AP1000 TECHNICAL REPORT REVIEW

Response to Request For Additional Information (RAI)

RAI Response Number: RAI-SRP3.7.1-SEB1-11

RAI Response Number: RAI-SRP3.8.2-CIB1-01

RAI-SRP3.7.1-SEB1-11-1: Seismic Response Spectra on roof of Shield Building X-Direction

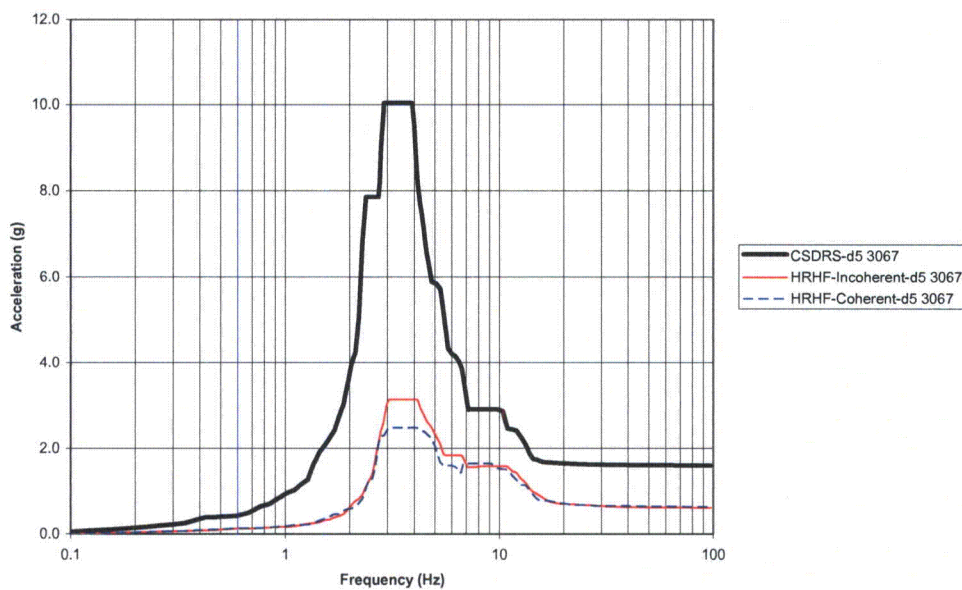
The staff requests that Westinghouse provide additional figures in Section 5.2 TR-115, to include all location/direction combinations presented in the Section 5.1 figures, and to provide a cross-reference between the corresponding 5.1 and 5.2 figures.

In response to the NRC's request to supplement Section 5.2 in the TR-115 during May 19-23, 2008, Westinghouse has provided incoherent and coherent comparison response spectrum for the nodal locations presented in TR-115 Section 5.1. These spectra are presented below in Figure RAI-SRP3.7.1-SEB1-11-1 to RAI-SRP3.7.1-SEB1-11-9 (5% damping).

RAI SRP3.7.1-SEB1-11-11: Node 1047 SRSS X Direction, Southeast Corner through RAI SRP3.7.1-SEB1-11-25 have been updated and replaced by figures RAI-SRP3.7.1-SEB1-11-68 to RAI-SRP3.7.1-SEB1-11-82

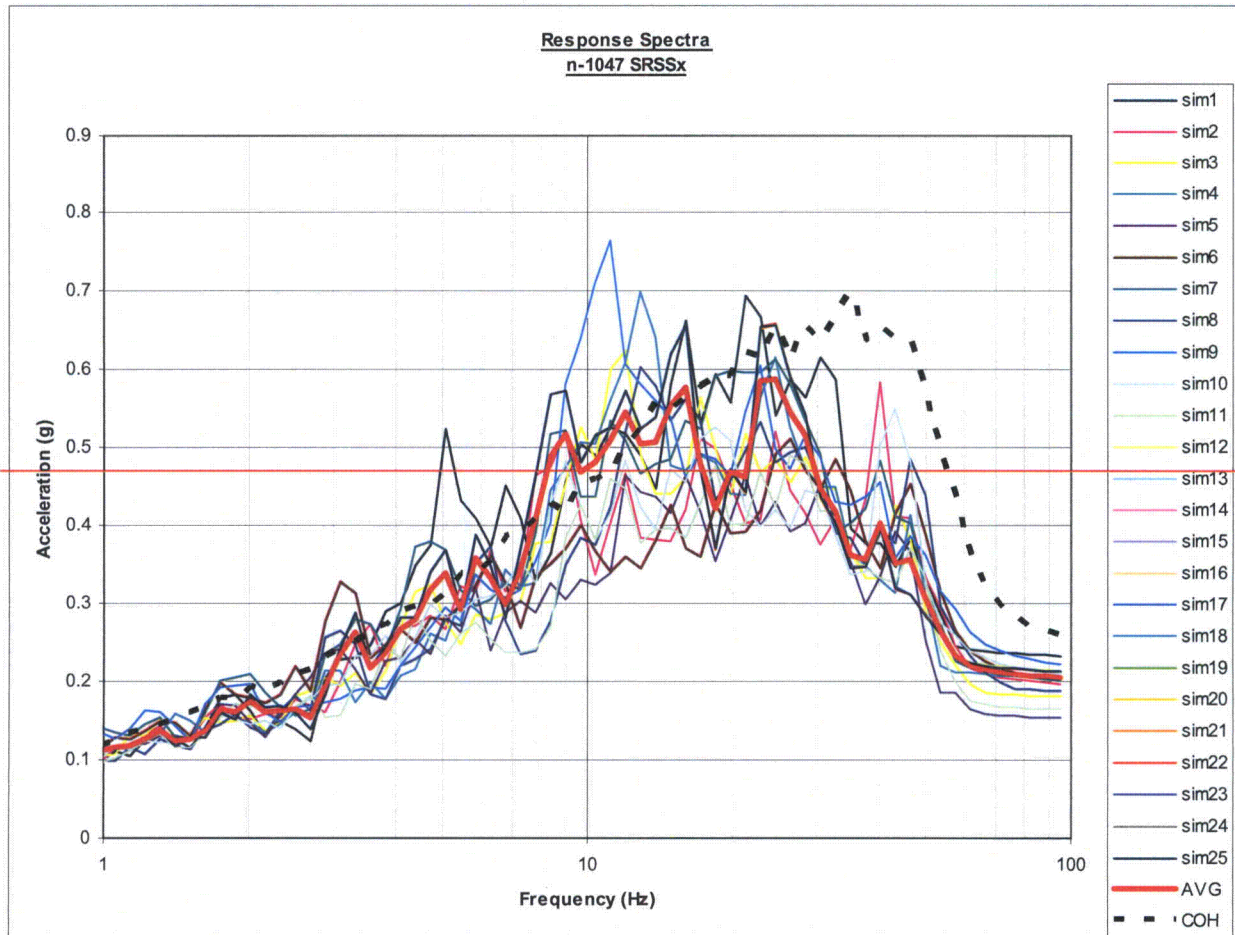
More data, i.e., HRHF response spectra for 5 locations on the basemat (4 locations at 4 corner and center) comparison of coherent at 5 nodes, 25 samples of incoherent and average of 25 incoherent response spectra.

Westinghouse is requested to update figures provided as part of previous revisions that are changed as a result of the revised responses.

In response to an NRC request, Figures RAI-SRP3.7.1-SEB1-11-11 through RAI-SRP3.7.1-SEB1-11-25 have been updated and replaced by Figures RAI-SRP3.7.1-SEB1-11-68 through RAI-SRP3.7.1-SEB1-11-82.

Figure 1: Inadvertent Fan Cooler Case at T = -40 F

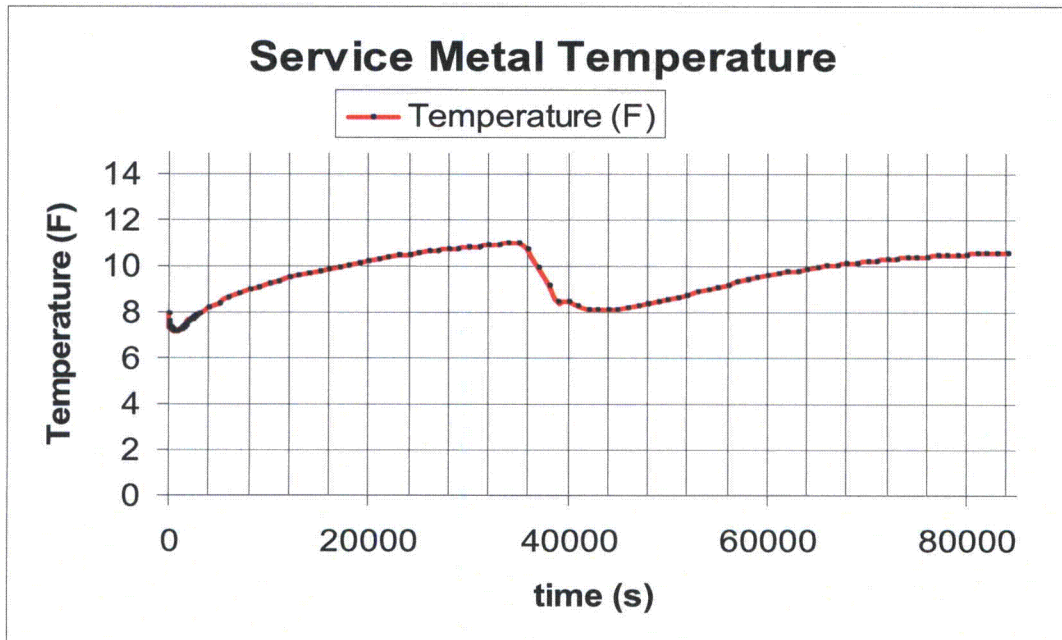
1) Please provide a plot of the containment shell temperature response in cold conditions discussed in the RAI response, similar to Figure E-1 provided in response to RAI-SRP-6.2.1.1-SPCV-07 (e). This plot covers the part of the transient used to establish steady-state initial conditions

1. There is one transient type that challenges the minimum service metal temperature requirement of -18.5 F. These transients are an inadvertent actuation of the active containment cooling system (VCS). These transients are discussed in depth in RAI-TR09-008. Figure 1 depicts the inadvertent fan cooler operation case at the minimum safety analysis temperature of -40°F, and an additional case at -30 °F. The WGOTHIC computer code was used to analyze these transients. Figure1 shows the minimum service metal temperature for the inadvertent fan cooler case. The transient was completely contained in one case. The case was allowed to equilibrate for 35000s before transient initiation. Operator action is assumed to occur within 60 minutes to shut off the fan coolers and return the transient to normal conditions. Figure 2 depicts the inadvertent fan cooler case at -30°F. This case is evaluated for containment shell temperature because wind speed at -30°F ambient condition is recorded to be faster than at -40°F resulting in a higher velocity through the annulus between the containment and air baffle

and therefore greater heat transfer. The increased heat transfer results in a lower shell temperature. For Figures 1 and 2 the minimum service metal temperature is 7.18°F for the -40°F case and -0.61°F for the -30°F case. The transient cases along with the entire spectrum of analyses considering the external pressure and minimum service metal temperature can be found in APP-MV50-Z0C-039 Rev. 0.

Figure 2: Inadvertent Fan Cooler Case at T= -30 F

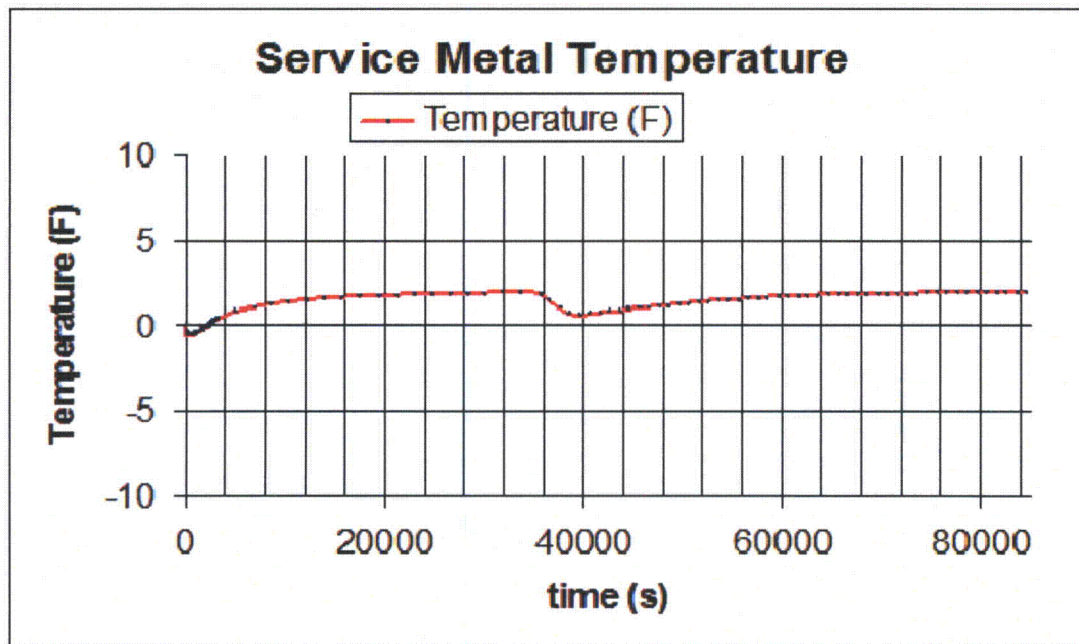
1. Your response to RAI-SRP3.8.2-CIB1-01, states that the -30° F external temperature case was used to evaluate the containment shell temperature because wind speed at -30°F is recorded to be faster than at -40°F resulting in a higher velocity through the annulus between the containment and air baffle and therefore greater heat transfer. The NRC staff notes that Westinghouse Document APP-MV50-ZOC-039, Revision 0 used minimum temperatures and corresponding wind speeds from Duluth, Minnesota.

Figure 3: Containment Pressure for LOAC transient at -40 F and 25 ft/s.

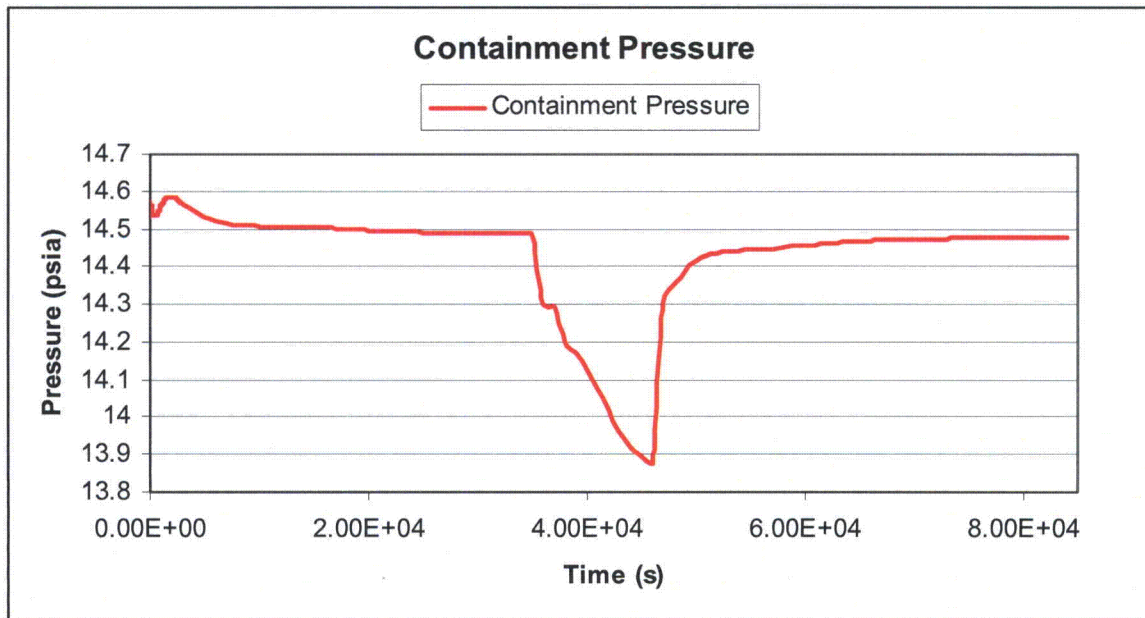
- a. perform a bounding calculation using an outside temperature of -40 °F and a maximum wind speed of 48 mph, used in previous calculations, or provide the following information:

1. To facilitate the staff's closure of this RAI, a bounding case was analyzed to provide an indication of the margin to acceptance criteria associated with the minimum allowable service metal temperature for the AP1000 Containment Vessel. From APP-MV50-Z0C-039 Rev. 0, the LOAC transient (Case 11) at -40°F yielded the lowest service metal temperature of 7.32°F (Note this was the lowest service metal temperature for the -40°F transients). For this reason, Case 11 was used as a representative transient to develop a bounding scenario to demonstrate the associated margin to acceptance criteria.

Figure 7: Containment Shell minimum service metal temperature for LOAC transient at -40 F and 25 ft/s.

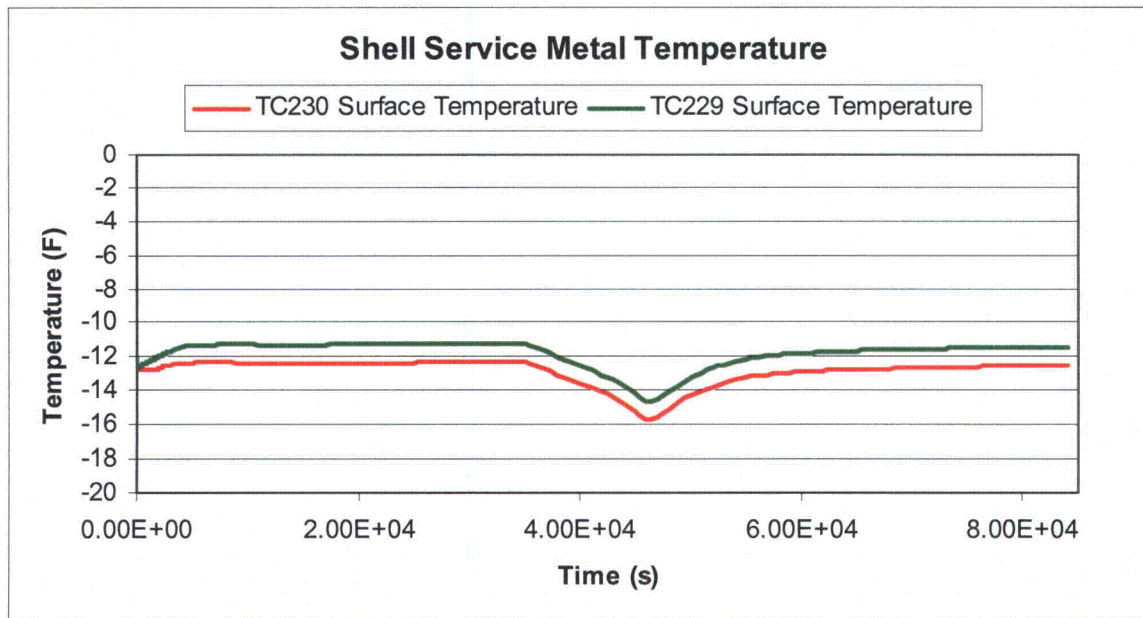
4. Westinghouse Document APP-MV50-ZOC-039, Revision 0 states that the minimum service metal temperature is calculated at TC230 level. Confirm that this location is near the bottom of the air baffle plate, and provide the elevation as shown in Figure 3.8.4-1 of the DCD.

Figure 7 reports the service metal temperatures for TC230 and TC229. TC229 is included to show that the temperature distribution is fairly uniform from the 135.25' elevation to the 170.0' elevation (top of TC229). This makes sense, as due to the velocity of 25 ft/s a particle of air traveling within the uniform velocity streamline in the constant velocity riser region would only take approximately $34.25\text{ft}/(25\text{ft/s}) = 1.39$ seconds to transport above the top elevation of TC229. Analysis of the raw data shows that the maximum temperature difference between TC229 and TC230 is just less than 1.3 °F for the duration of the transient. Application of this temperature difference to the raw data as an uncertainty in the temperature reported for TC230, would yield a minimum service metal temperature of $-15.78\text{ °F} + -1.13\text{ °F} = -16.91\text{ °F}$. This is still greater than the DCD minimum required service metal temperature of -18.5 °F .
